**Addendum No. 1**  
**January 13, 2023**

Project: Baltic High School Addition  
Baltic, South Dakots  
Arch Project No. 2957

Architect: Architecture Incorporated

**8.22**

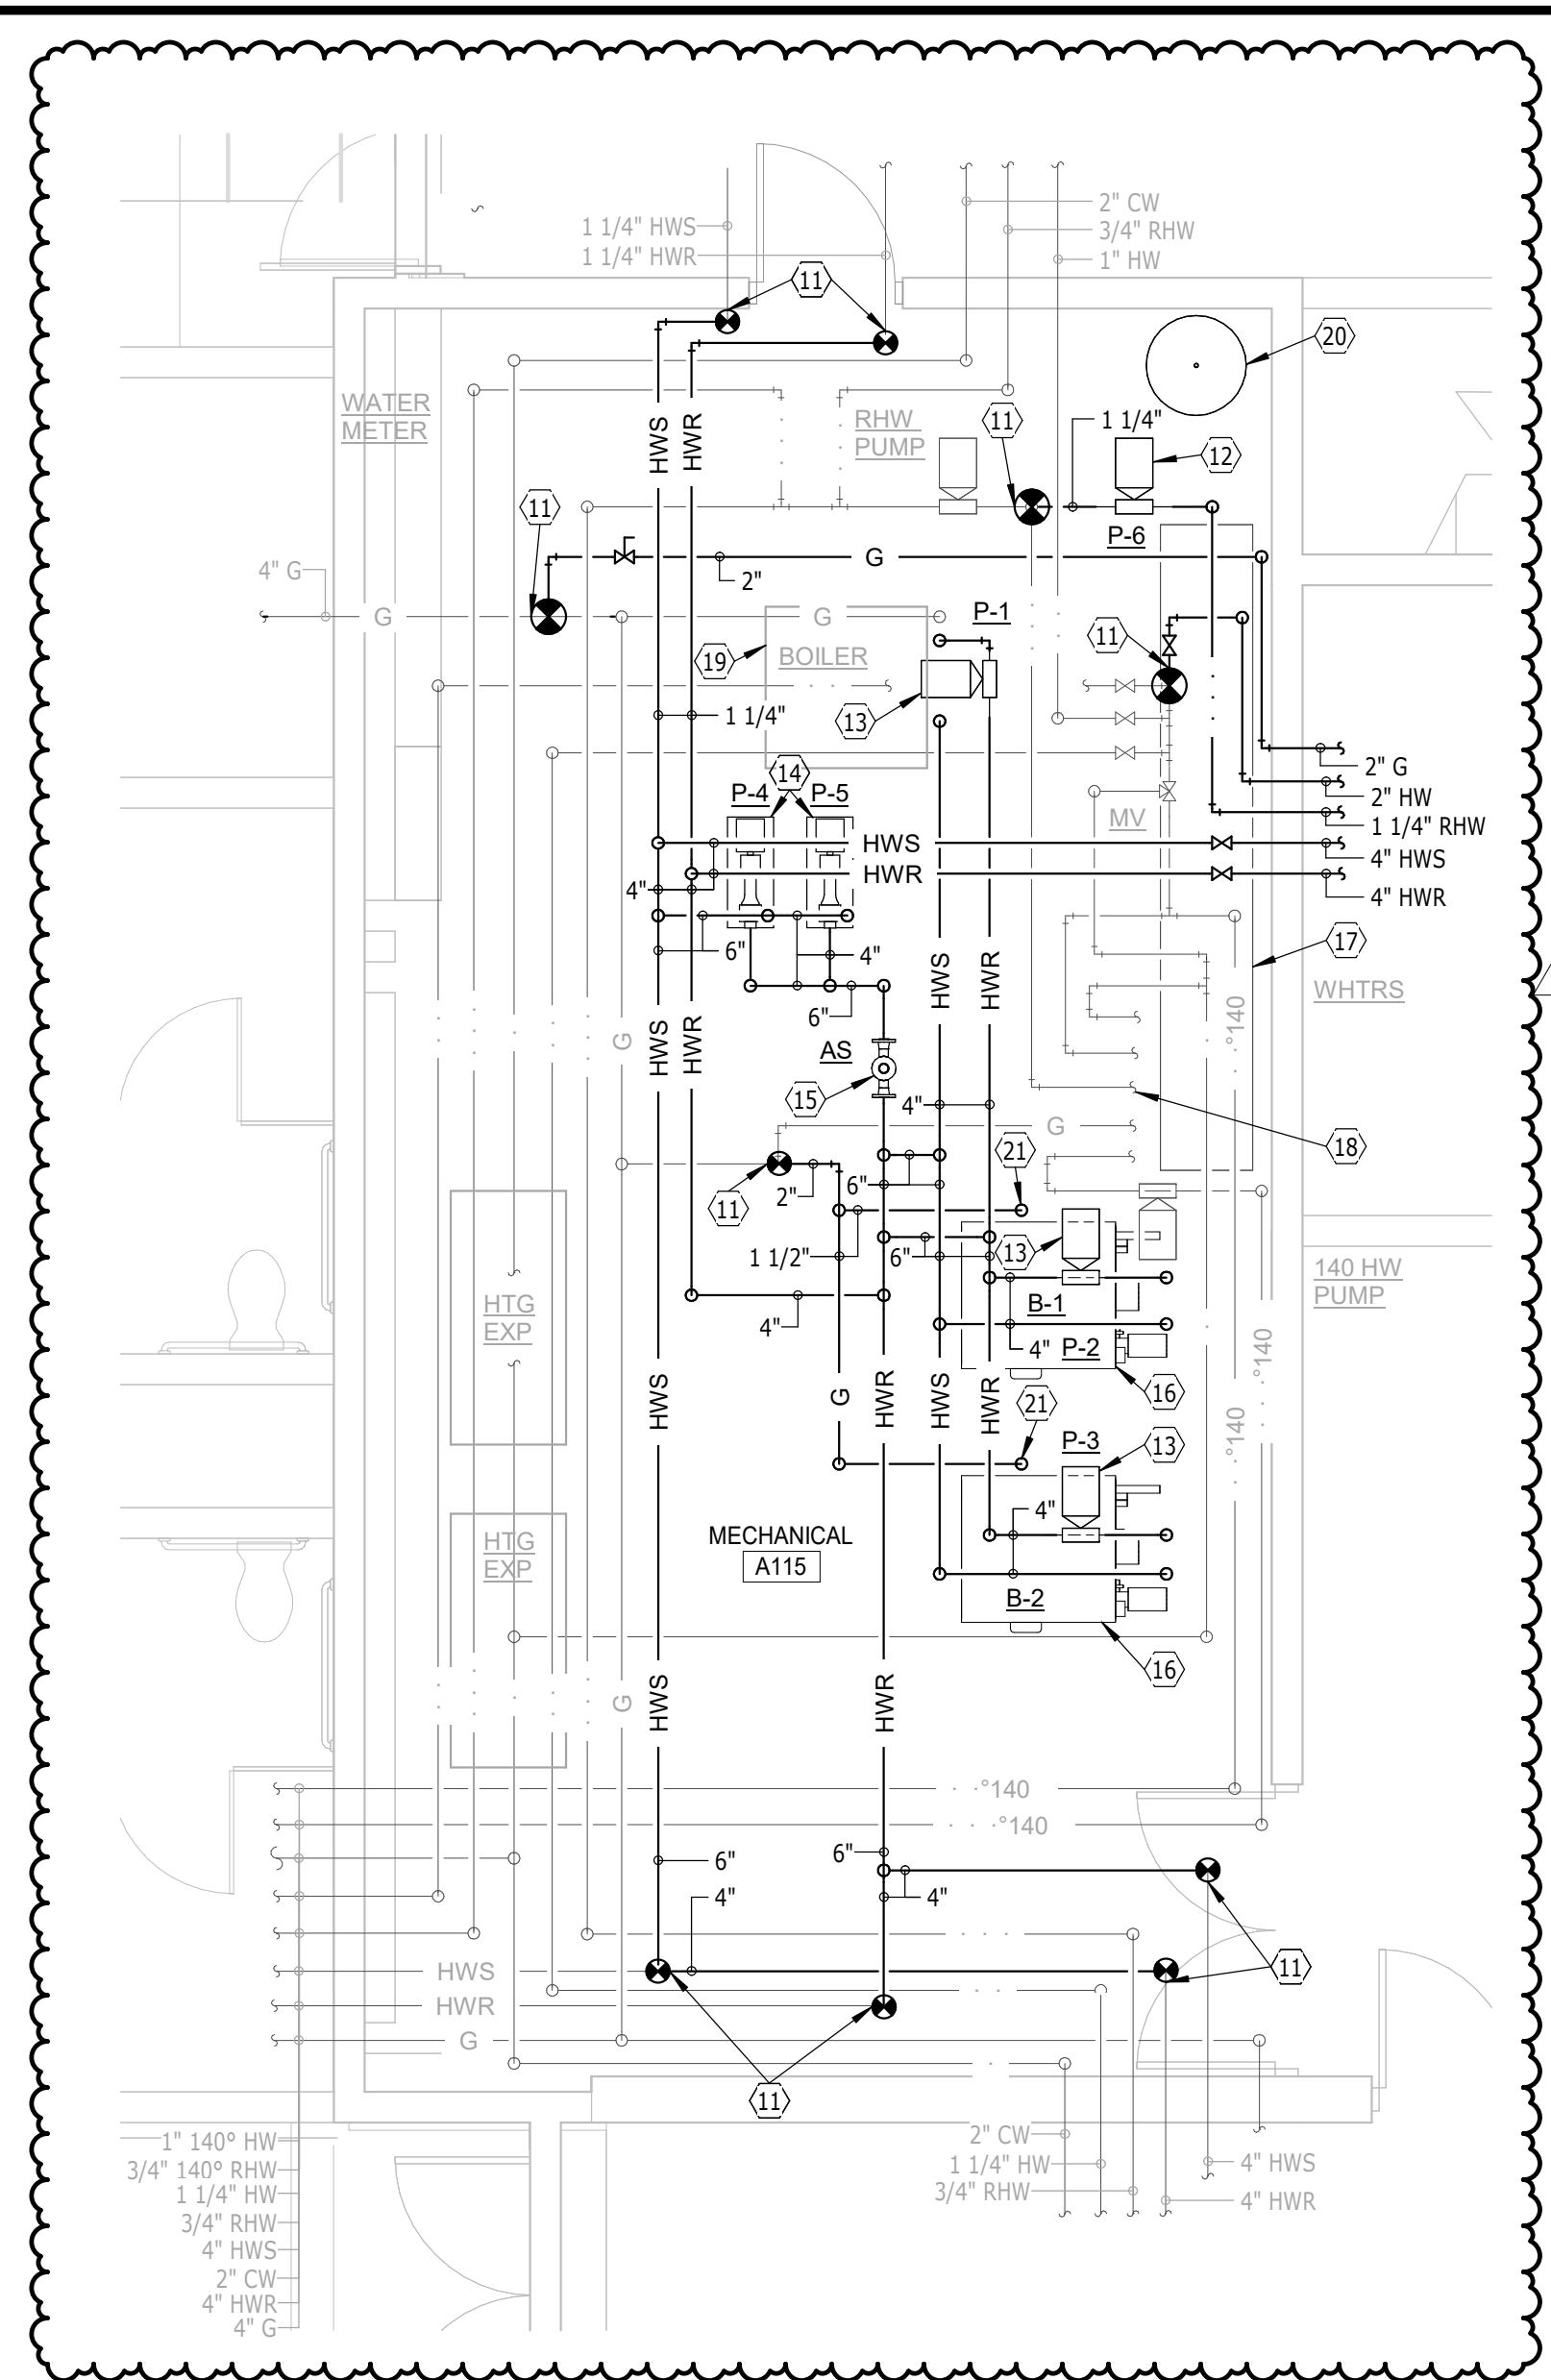
3) DRAWING SHEET 8.22 – FLOOR PLAN – DEMOLITION – VENT & A/C

- a) Demo combustion air duct. Louver to remain. Insulate, cap, and seal intake louver wall sleeve. Refer to revised Drawing Sheet 8.22, Addendum 1, dated 1/13/23.
- b) Demo boiler flue. Coordinate roof patch with general contractor. Refer to revised Drawing Sheet 8.22, Addendum 1, dated 1/13/23.

**8.35**

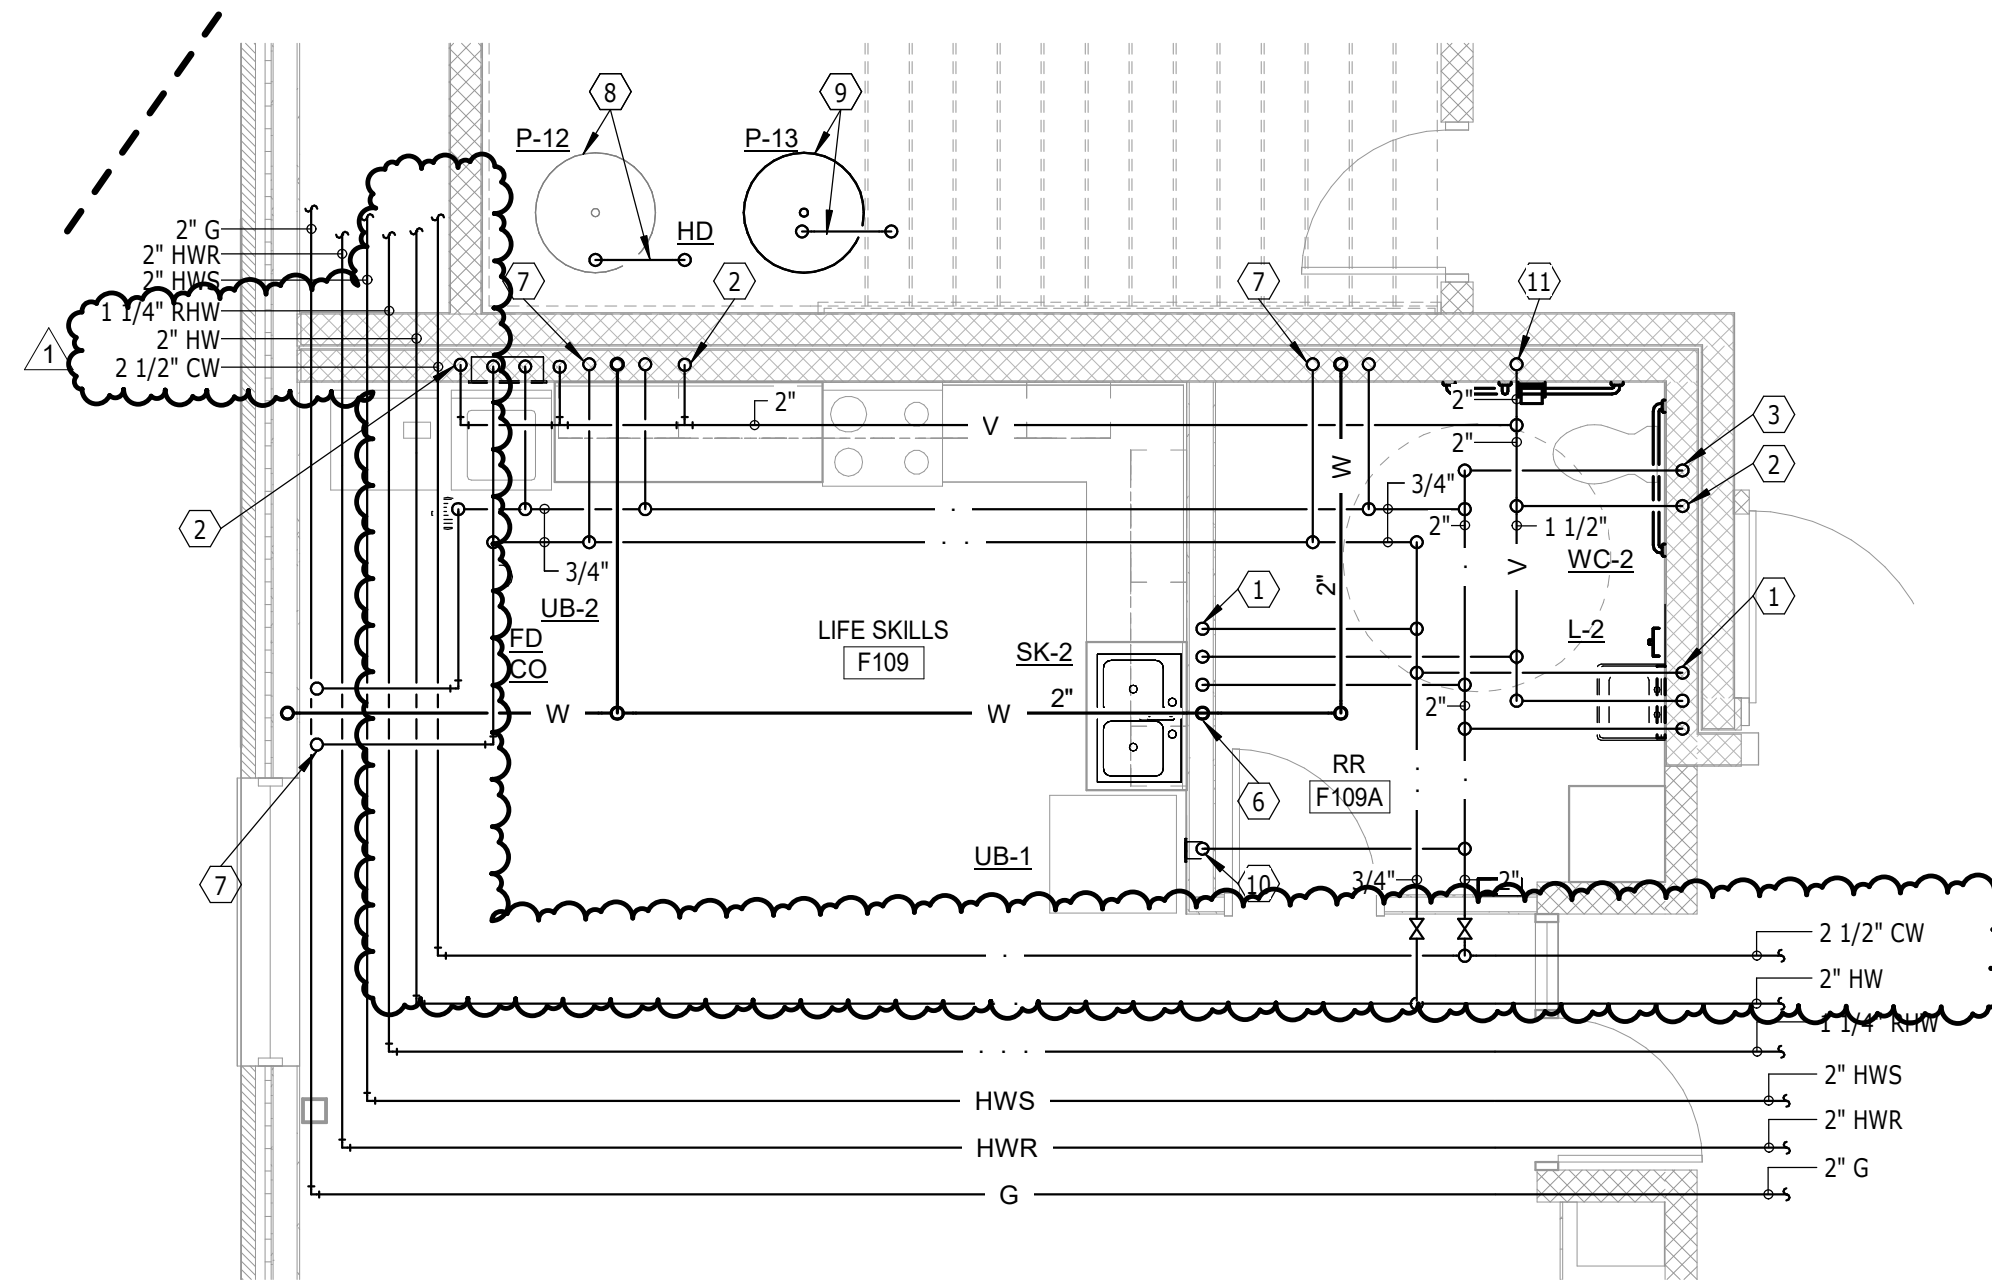
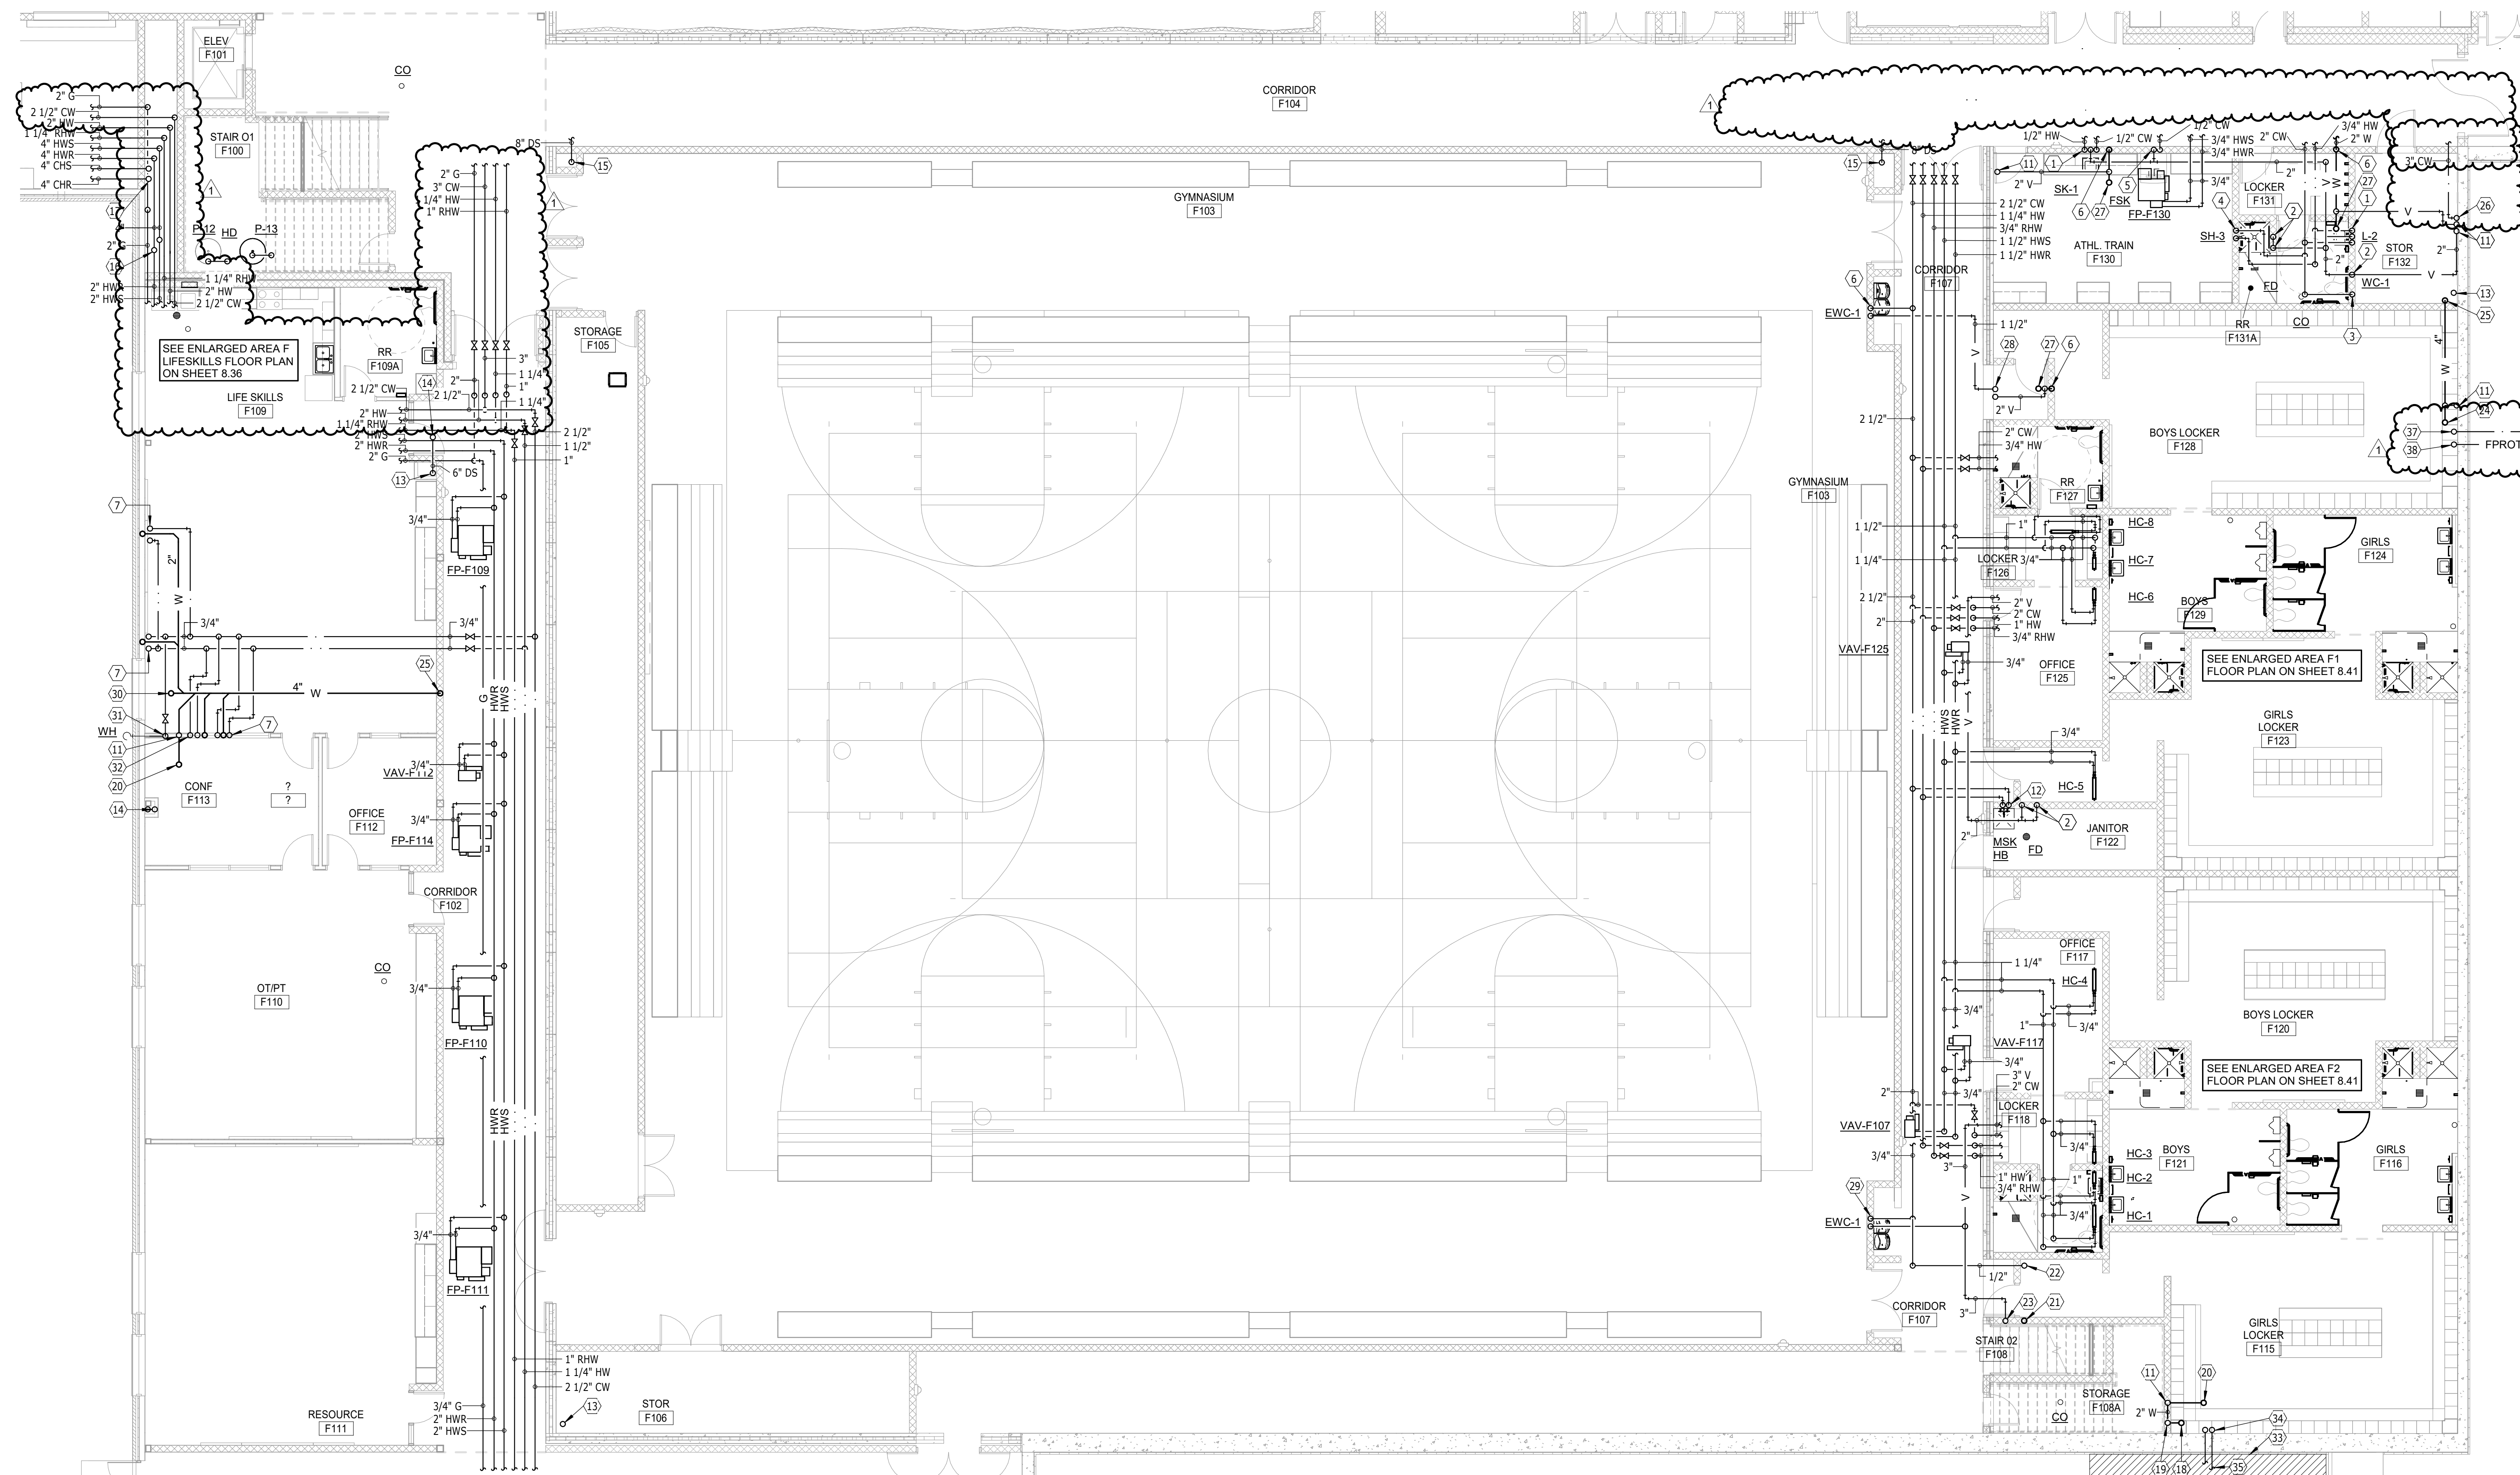
6) DRAWING SHEET 8.35 – FIRST FLOOR PLAN – AREA E – PLUMBING & HEATING

- a) Modify CW piping size as shown. Refer to revised Drawing Sheet 8.35, Addendum 1, dated 1/13/23.
